**PLANNED UNIT DEVELOPMENT
& SUBDIVISION STAFF REPORT****Date: August 4, 2011****DEVELOPMENT NAME**

Llanfair Place Subdivision

CONTEMPLATED USEPlanned Unit Development Approval to amend a
previously approved Planned Unit Development to allow shared access and parking across
multiple building sites, and Subdivision approval to create 3 lots.**TIME SCHEDULE****FOR DEVELOPMENT**

SITE PLAN

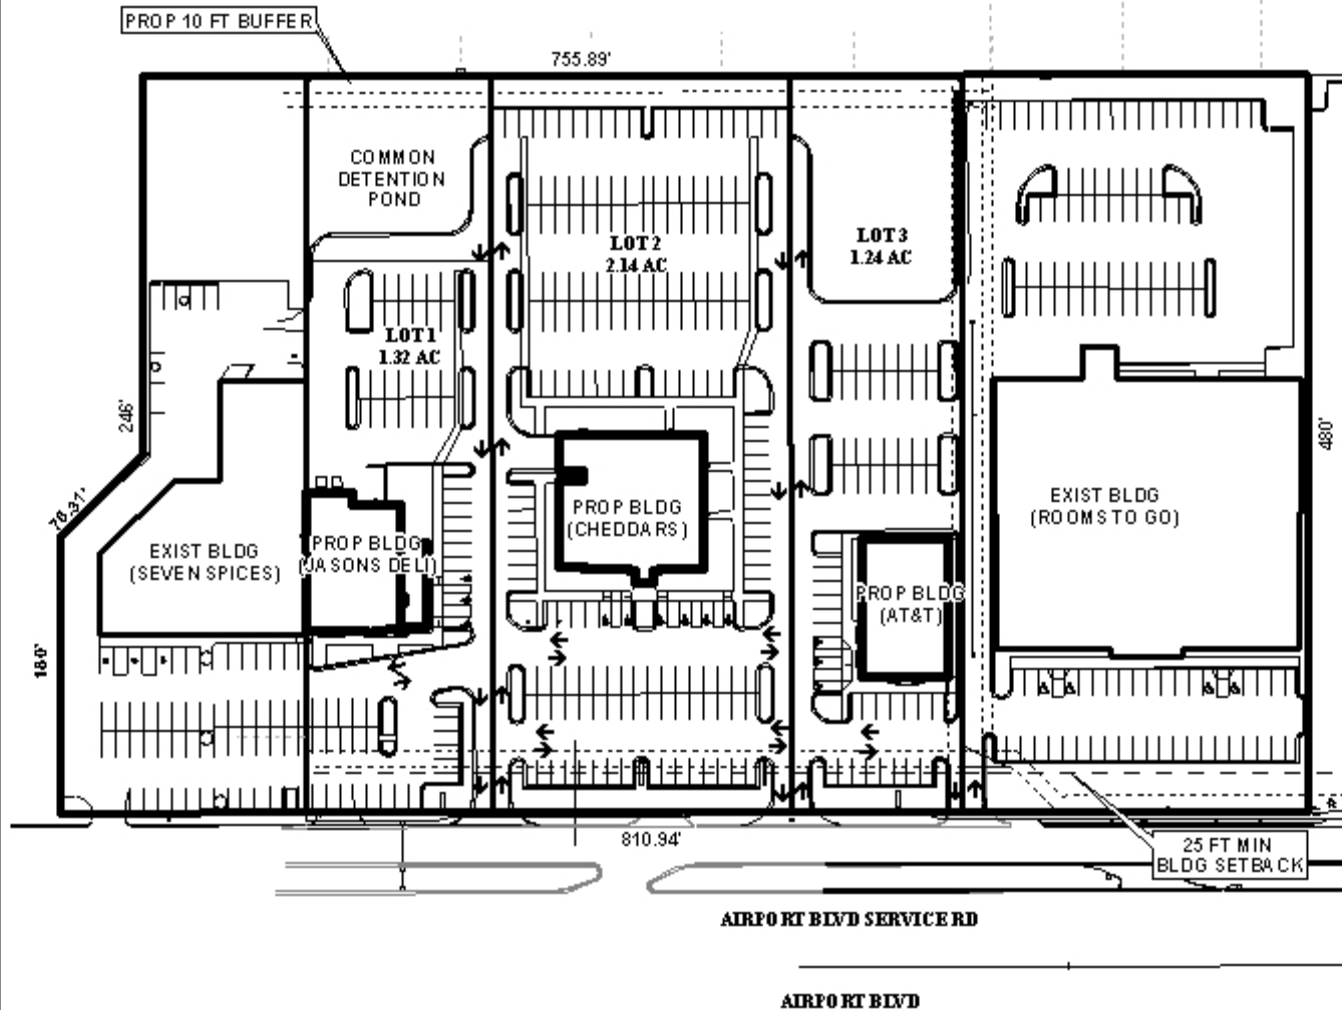
It should be pointed out that there are also deficiencies in the site plan provided, in that proposed dumpsters are not indicated, tree compliance is not indicated, fence buffering is not indicated, and parking does not appear adequate. Furthermore, the adjacent residential development necessitates that additional information be provided regarding the lighting of the site so that staff can evaluate if adjacent residences will be adequately protected from the site. Parking for the

proposed Jason's Deli does not appear to include spaces to address the proposed outdoor seating, and the Catranis/Ladas site should include information for each business suite so that parking can be calculated for the multiple uses within the building.

Traffic Engineering has stated that a Traffic Impact Study will be required for the development. It should also be pointed out that if any of the existing or proposed businesses will be served by tractor-trailers, it should be demonstrated that there is adequate maneuvering area for such vehicles to access and move through the site.

Finally, it does not appear that the overall revised site plan submitted depicts compliance with the requirements of the Americans with Disability Act (ADA), in that the Rooms To Go site may lack the appropriate number of parking spaces, that the ramping is within the required access route, and that all sites may lack the required accessible route from the public sidewalk located on the Airport Boulevard service road to the accessible entrance of each building or business. The design professional should verify that the site complies with the requirements of the ADA.

Subdivision: Based upon the preceding, this application is recommended for Withdrawal so that a new application for Planned Unit Development can be submitted showing the Llanfair Place site, the Catranis/Ladas site and the Rooms To Go site as one PUD application, with appropriate letters of authorization from the property owners and the necessary adjacent property owner information.

Planned Unit Development: Based upon the preceding, this application is recommended for Withdrawal so that a new application for Planned Unit Development can be submitted showing the Llanfair Place site, the Catranis/Ladas site and the Rooms To Go site as one PUD application, with appropriate letters of authorization from the property owners and the necessary adjacent property owner information. Furthermore, the site plan submitted for the PUD application should depict full compliance with the requirements of the Zoning Ordinance (including location of dumpsters and existing/proposed trees), and a Traffic Impact Study will be required, per the comments of Traffic Engineering. The site plan should include templates addressing access by tractor-trailers if deliveries will be made by large trucks.
